TO: Water Right File 95-13374

SUBJECT: Licensing Review of Water Right 95-13374

STATE OF IDAHO
DEPARTMENT OF WATER RESOURCES
BENEFICIAL USE FIELD REPORT

THE FALLS AT HAYDEN LAKE
BENEFICIAL USE REPORT NARRATIVE
WATER RIGHT PERMIT NO. 95-13374

The Falls at Hayden Lake

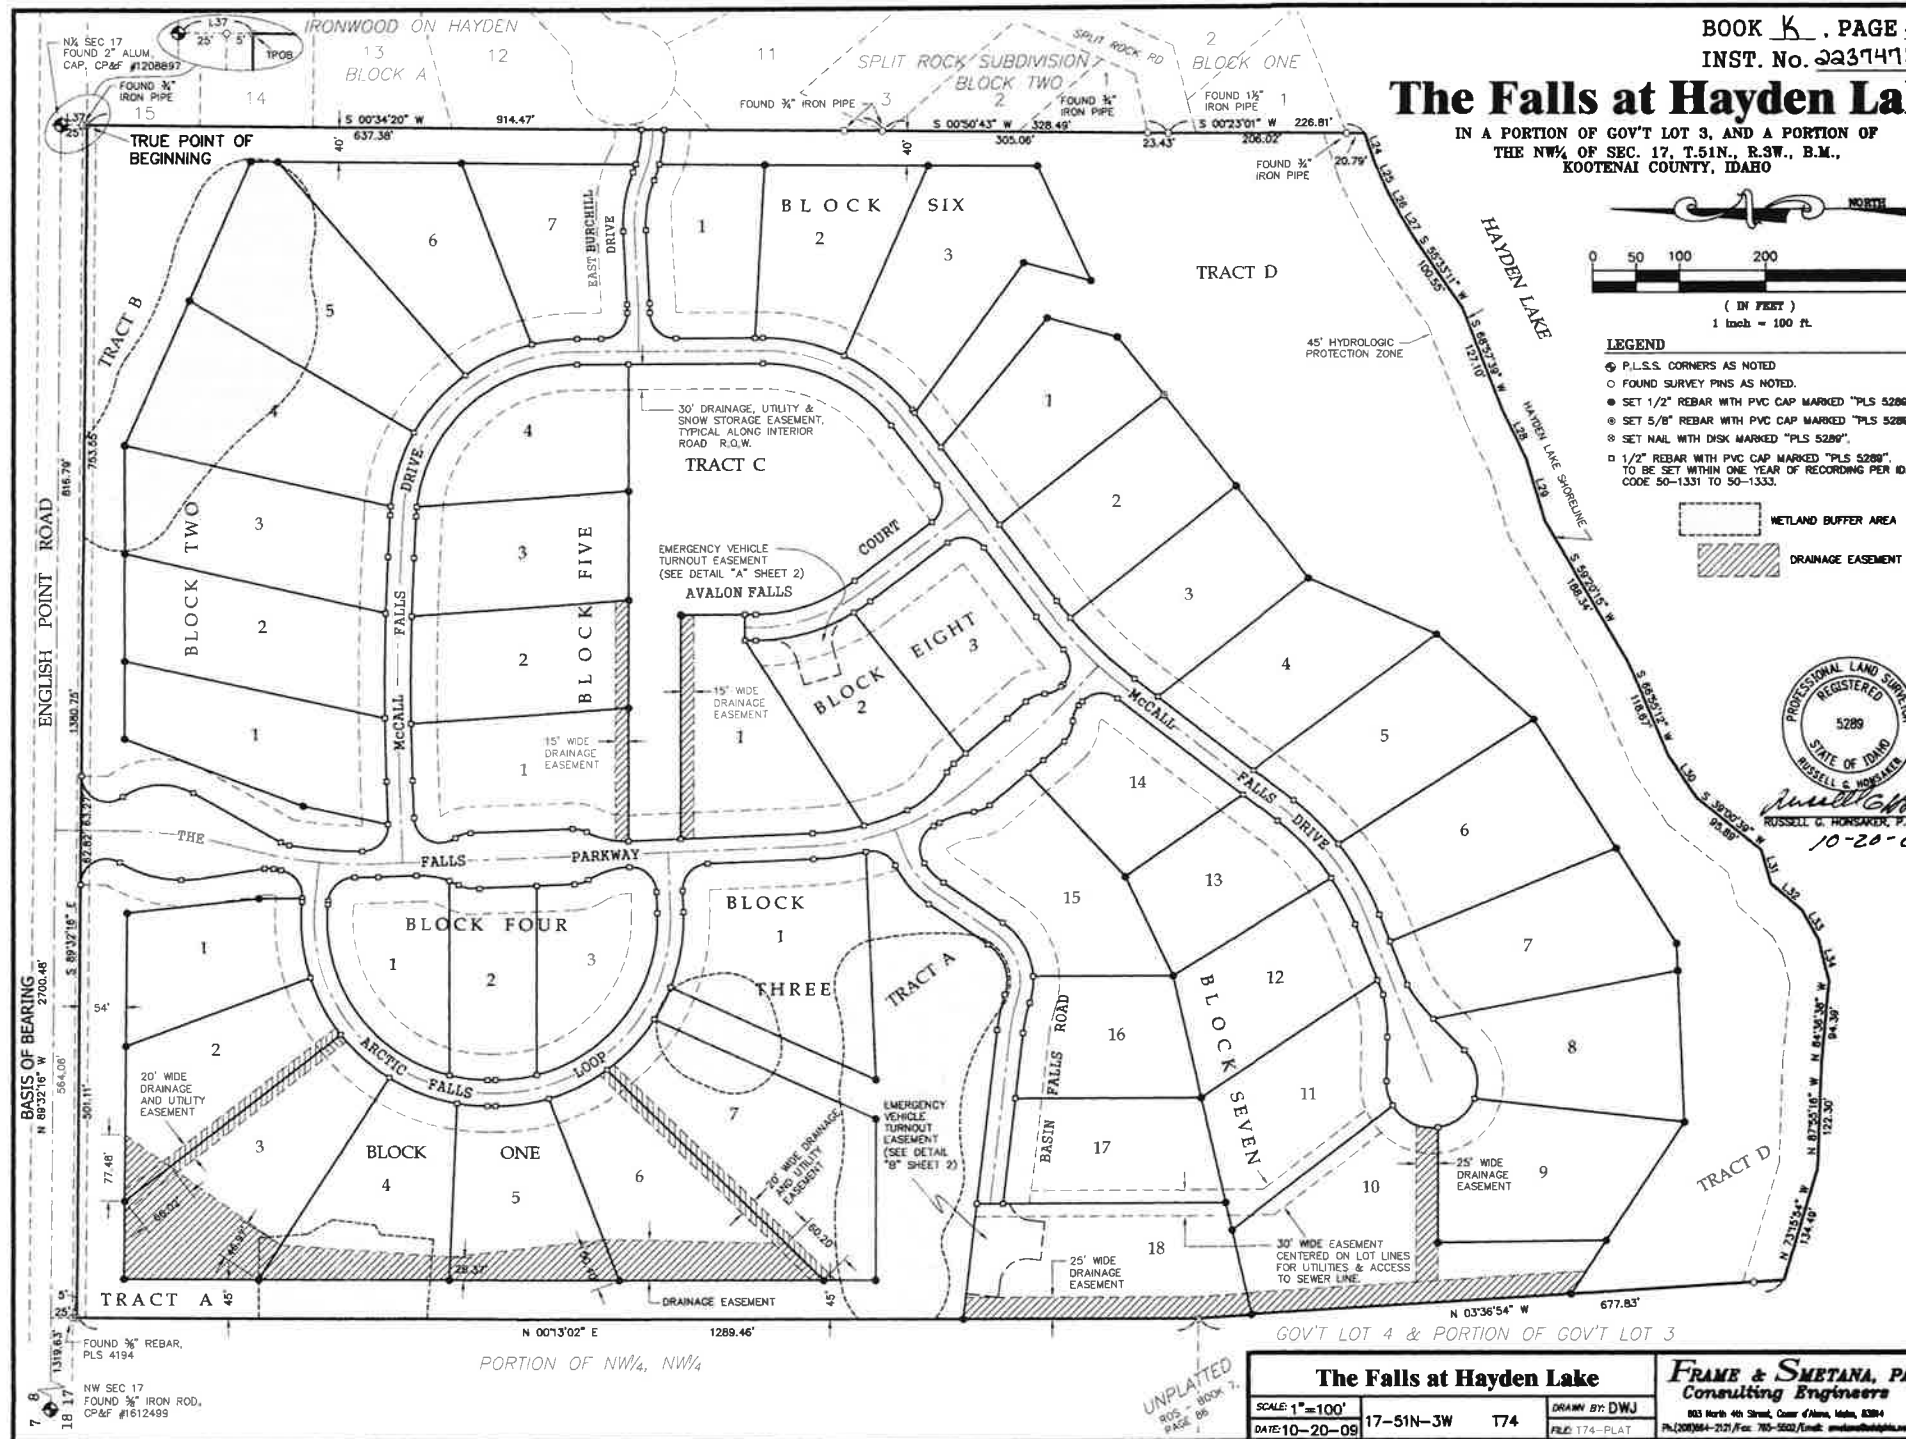
PLEASE NOTE: The permit placed the point of diversion in Government Lot 3 (SENW) of Section 17, Township 51 North, Range 3 West. The field examiner also stated that the point of diversion was in Government Lot 3. The Point of diversion is in what is called in the plat map as the Hydrologic Protection Zone, so it is outside of Government Lot 3. The point of diversion is in the SENW, but it is not in Government Lot 3. No amendment is necessary to correct this, since Government Lot 3 includes a portion of the SENW. This is just to clarify the location to match the Public Land Survey and the Plat Map supplied to the county. Please see the attached plat map attached to this memorandum.
